Planning Committee – Hybrid Meeting

Date: 1st February 2023

Subject **Planning Application Schedule**

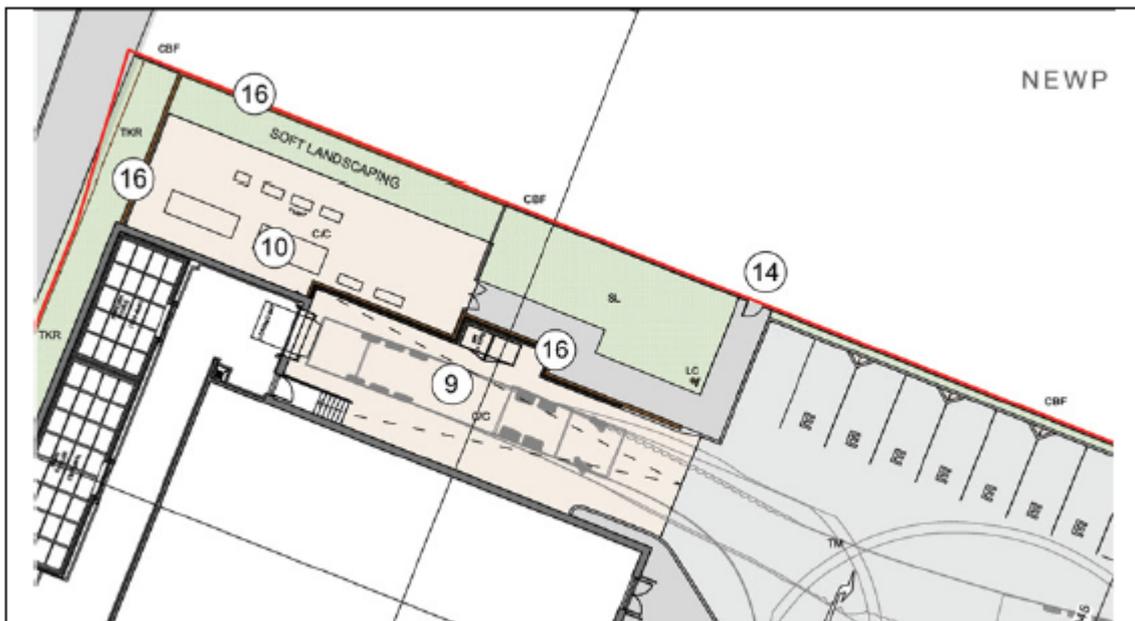
The future route INM-CAE-0002(a/b) is labelled as walking and cycling, so a 1.8m footway wouldn't suffice.

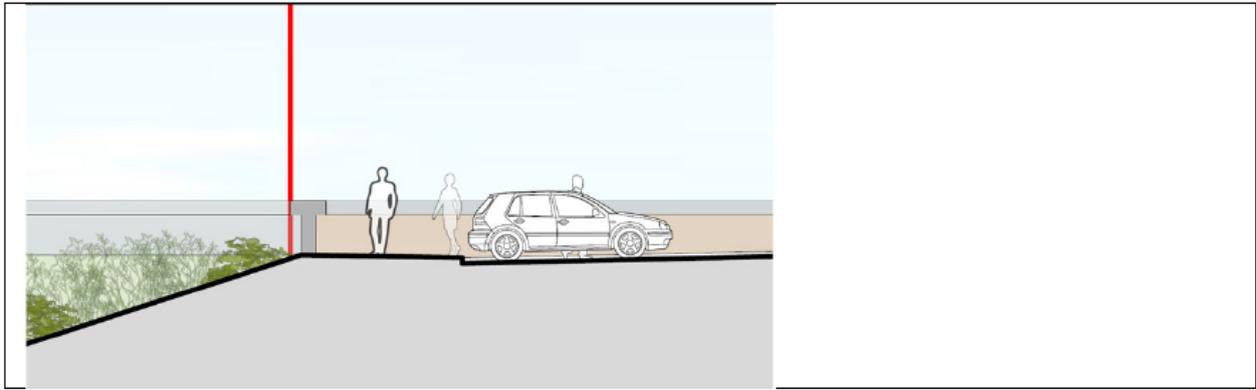
1. Planting to the north boundary shows a native hedge in a bed width which may be under 1m width and which is backed by a proposed 1.8m high close boarded fence. Can Tyler Grange confirm this is workable – see image below.
